# INSTRUCTION TO SERVICE

ITS-61479		10/30/2025
<b>SECTION:</b>	292 - Electrical Harnesses	
<b>SUBJECT:</b>	Rework center axle encoder harnesses.	
<b>ISSUE:</b>	Encoder harness connector terminals become corroded due to moisture ingress.	
<b>SUMMARY:</b>	Supplier has lengthened the temperature and speed sensor harness to 2.5 meters. Existing harness will be shortened to move connectors to the interior of the bus.

# ITS-61479

**Figure 3: Curbside X2 Connector, Tyrap and P-Clamp locations.**

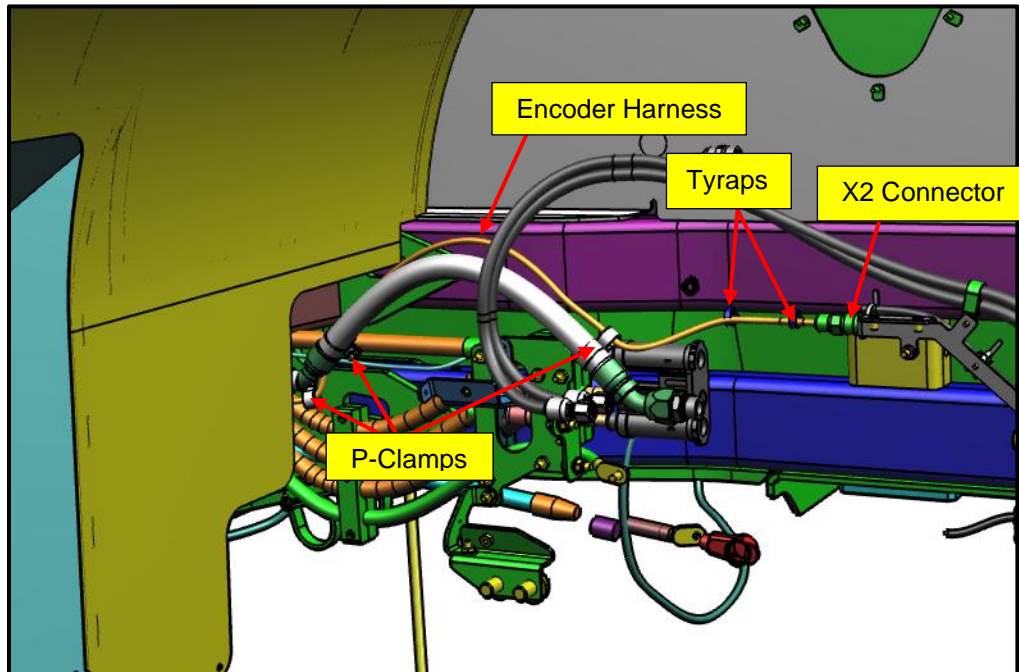
5. Verify the Low Voltage and High Voltage Systems are disabled. Refer to Section 1.7 “De-Energizing & Energizing Procedure in the Service Manual or Appendix A in this ITS.
6. Remove both curbside and streetside aisle facing wheelhouse seats by removing the mounting hardware on floor and rear side of the seat. Set aside for reinstallation later.

**Figure 4: Curbside X1 Connector and P-Clamp locations. Exterior Panels are hidden.**

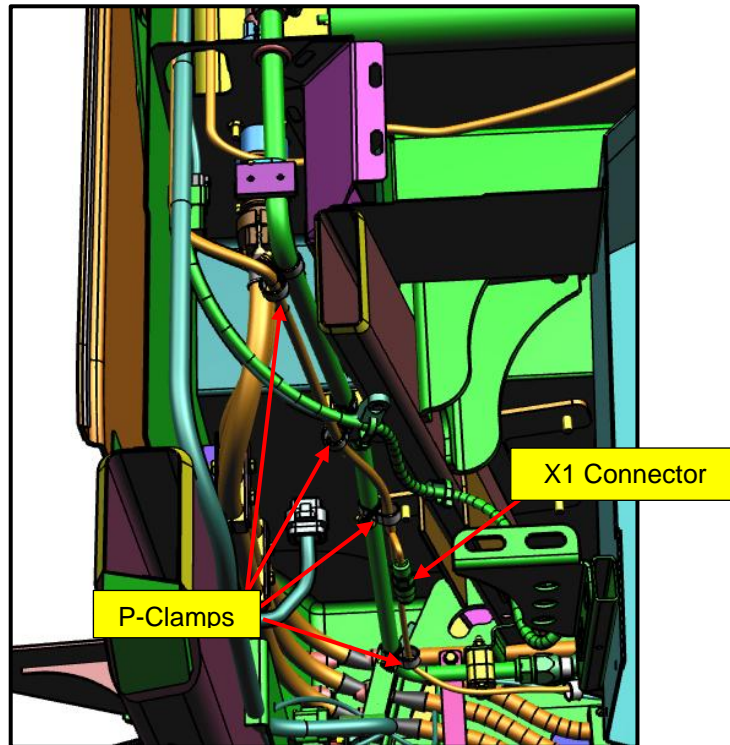
11. Locate the encoder cable X1 connector. Remove and set aside the four P-clamps that secure the encoder harness with the cooling hose.

**Figure 5: Existing Harness Cut Point**

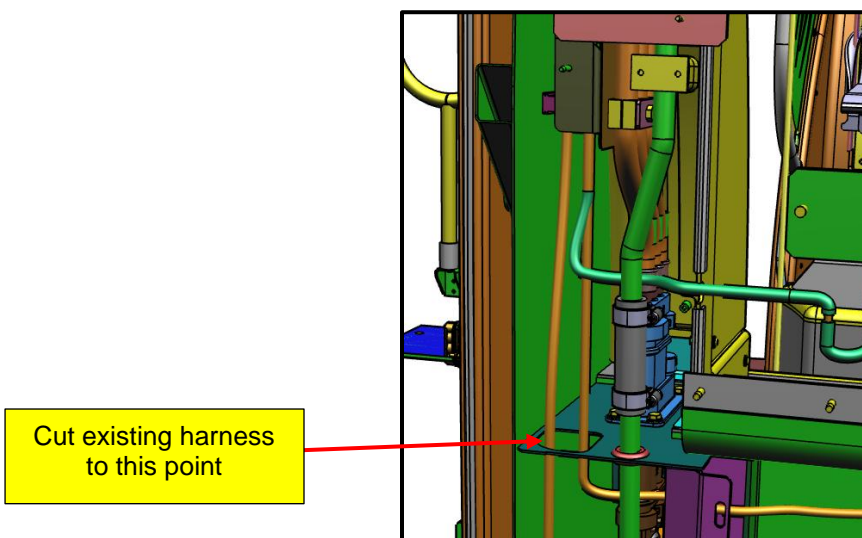
12. Cut the existing harness to the same level as the floor support bracket splitting the two cables with about 6" of cable length each.

**Note: Ensure cables remain identified, CTR DRIVE CS-X1 for temperature sensor and CTR DRIVE CS-X2 for speed sensor.**

**Figure 13: Finished Harness Sample**

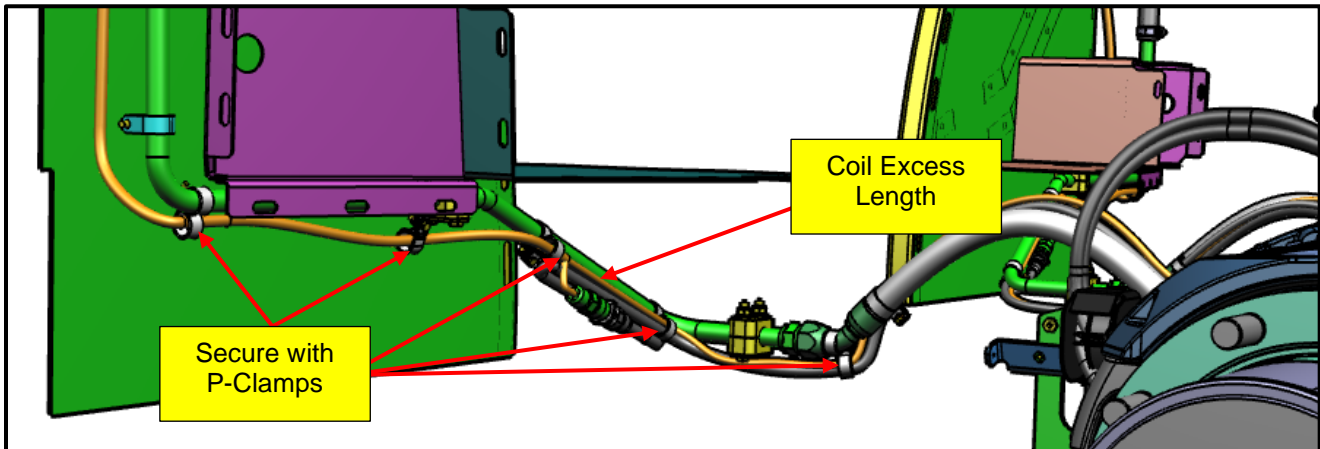
18. Relabel the harness as following using (NF PN: 8112067) at about 2-3" back from the connector body.

**Label Note: CTR DRIVE CS-X1 for temperature sensor and CTR DRIVE CS-X2 for speed sensor.**

**Figure 14: New Temperature and Speed Sensor Harness Routing on Cooling Line**

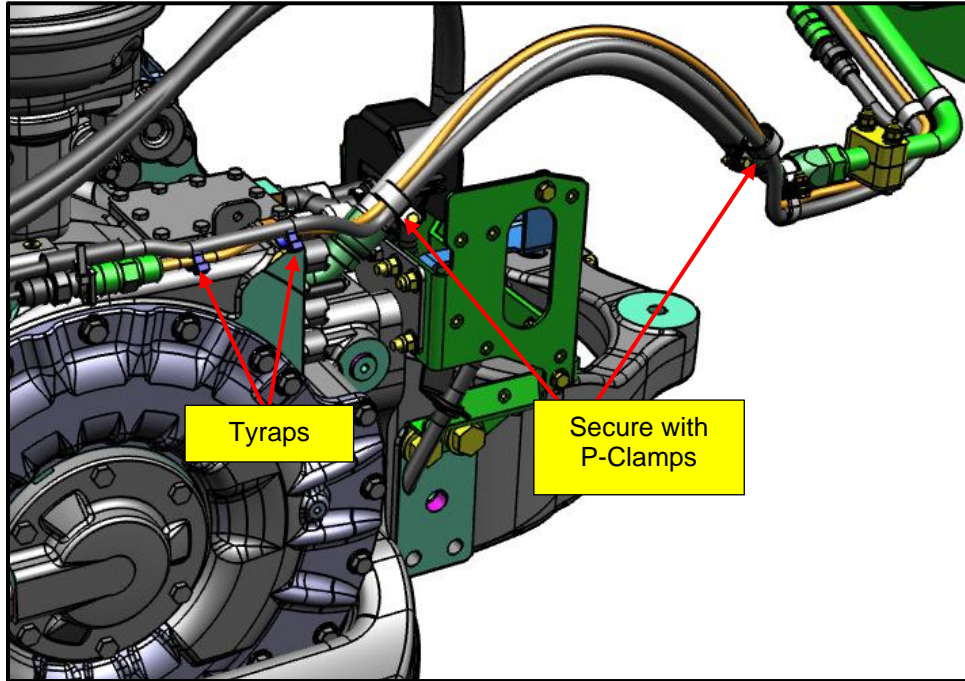
21. Route the new temperature and speed sensor cables along the center axle cooling line which is the same route as before. Secure new cables using the set aside P-clamps (NF PN: 514099), screw (NF PN: 22S00012) and lock nut (NF PN: 42N00000). As required, coil up excess length of new ZF sensors, See Figure 14 and 15.

**Figure 17: New Temperature and Speed Sensor Harness Routing on Center Axle**

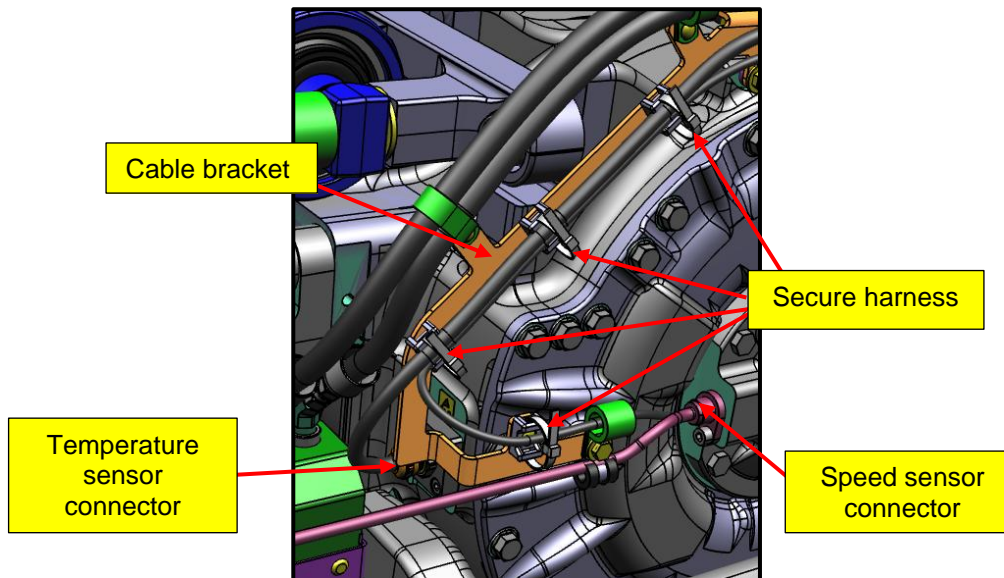
23. Secure the new temperature and speed sensor harness to the cable bracket in orange in Figure 14. Using cable tie mount (NF PN: 291987), tyrap (NF PN: 5958112) and self-tapping screw (NF PN: 34S00006). Connect the temperature and speed sensor to the center axle.
